**Addendum No. 001**

**Subject: Schoolyard Improvement at Joseph Pennell School  
SDP Contracts No. B-066C of 2020/21**

**Location: Joseph Pennell Elementary School  
1800 Nedro Avenue  
Philadelphia, Pennsylvania 19141**

*Photo: Example of 'Little Free Library' site element, to be provided by Mural Arts.*

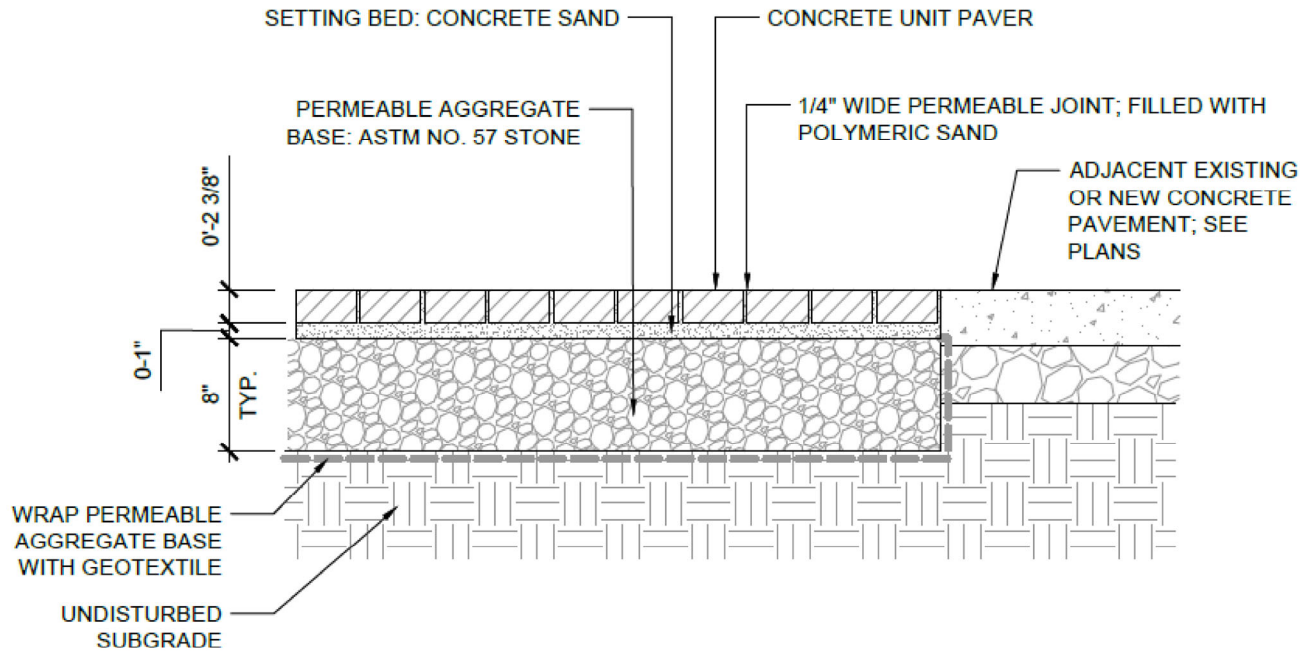
1. Notes 7 and 8 on Plan L-104 indicate that portions of the work will be performed by the Mural Arts contractor and are not included in the bid. Please provide a more detailed description of the work to be performed by Mural Arts in the Little Library Area. For example, is Mural Arts furnishing the benches and ottoman?

- a. RESPONSE: 'Little Free Library' is labeled on drawing 1, sheet L-104. It is located adjacent to plant bed, south of the Pre-School Building. This is the only element that Mural Arts will be furnishing. See attached image below for example of 'Little Free Library' for reference. All other elements -- except 'Little Free Library' --labeled on plan should be furnished and installed by Contractor.
